Crawford & Associates Engineering & Land Surveying, PC

September 6, 2024

**RE: ELP MARLBOROUGH SOLAR LLC
RUNOFF EROSION VELOCITY ANALYSIS
C&A #: 4996.26**

POST-DEVELOPMENT TOC PATHS
SCALE: 1"=100'

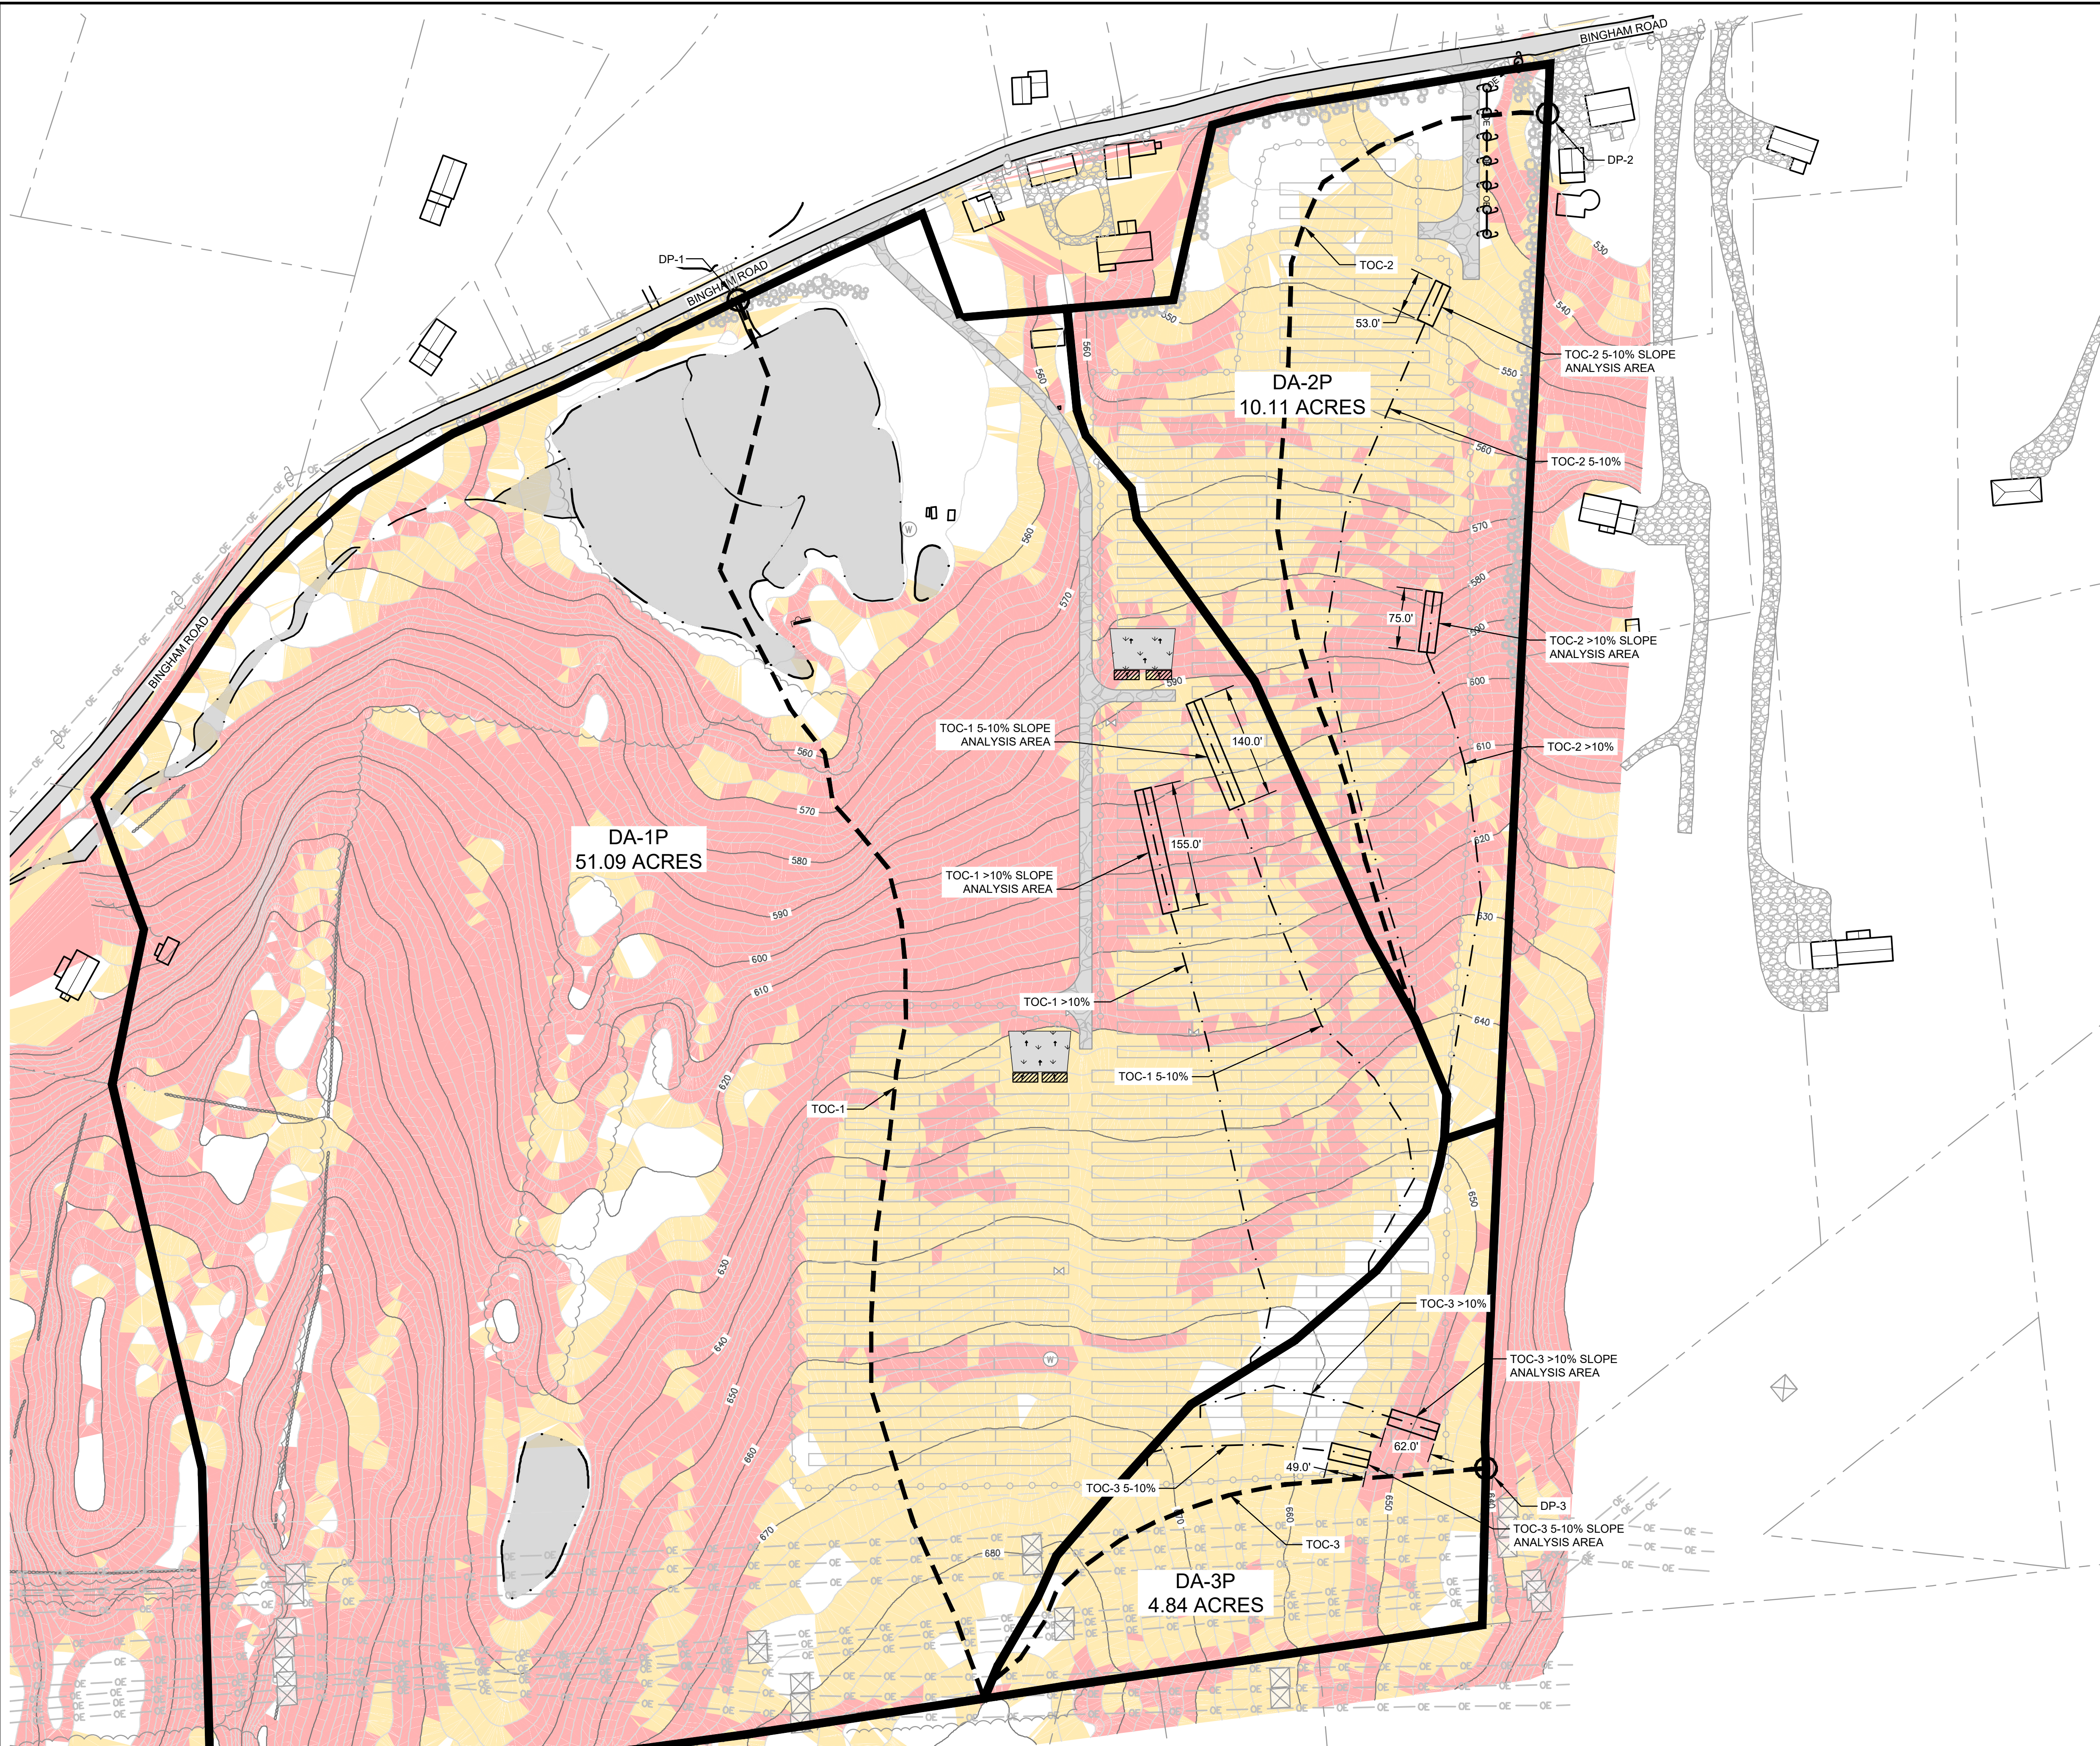
Per MHE Engineering comment, the project area was analyzed where slopes ranging from 5%-10% and exceeding 10% coincide with where solar modules are proposed not completely parallel with grade contours. These locations were analyzed to ensure stormwater runoff does not exceed the NYSDEC threshold for erosive velocity. Each post-construction drainage area, DA-1P through DA-3P was analyzed in multiple locations to determine the worst-case scenario for each drainage area, and to determine whether the erosive runoff velocity would be exceeded within the installation area.

The flow paths analyzed were selected by identifying high elevation points within the project as start points, flow paths passing through areas corresponding to 5%-10% and greater than 10% slope thresholds, and termination points at the toe of the steepest slopes, where velocity would be highest. All flow paths analyzed began as sheet flow runoff from the proposed solar modules then transitioned to shallow concentrated flow at the end of the module. Slope, surface description (short grass cover), and length of flow path in these locations were input to HydroCAD, assuming post development conditions, to determine the time of concentration for the selected flow path. HydroCAD output of time, in minutes, for the runoff to flow through these sloped areas to the termination points was used to determine runoff velocity, providing a near instantaneous velocity calculation. See Tables 1-3 below for the results of the analysis. Note that each table includes the average runoff velocity following the originally derived Time of Concentration (TOC) path from the drainage analysis, along with the maximum calculated velocity for the worst-case scenario slopes ranging between 5%-10%, and greater than 10% for each drainage area. Further, the distance listed in the below tables does not correspond to the total length of the TOC path, but rather to the length of the TOC path in the noted slope range, and ultimately used in the velocity

calculation. See attached a drawing which overlays the slope analysis with the locations of analyzed points for the scenarios indicated in the tables.

According to the [New York State Department of Environmental Conservation Stormwater Management Design Manual, July 31, 2024. Appendix G: Non-Erosive Velocities of Vegetated Channels](#), the maximum velocities for non-erosive flow allowed are between 2.5-5 ft/s depending on slopes and vegetative lining type. For slopes between 5-10%, the maximum velocity is 4 ft/s, and for slopes greater than 10%, the maximum velocity is 3 ft/s.

As shown in the results above, most analyzed points are below the maximum velocity thresholds. For the one which exceeds the threshold and other value approaching the threshold, it is important to recall that this analysis includes several conservative assumptions to provide the worst-case simulation of the post development conditions, including 100' or more of defined flow path, a short grass covered surface, an immediate transition from sheet flow to shallow concentrated flow when the water drips from the edge of the module, and the expected velocity at its absolute maximum. These assumptions are considered well conservative as the actual installed conditions will include lush grass vegetation to stabilize site soils, diffuse runoff, and limit shallow concentrated flow from occurring. Further, the runoff will not be at maximum velocity along the entire flow path, only at the toe of slope termination point. Therefore, it is anticipated that all actual runoff velocities will be below the calculated maximums, post-construction runoff flows on site will be considered non-erosive, and stormwater management features to further encourage sheet flow conditions will not be required for the installation.
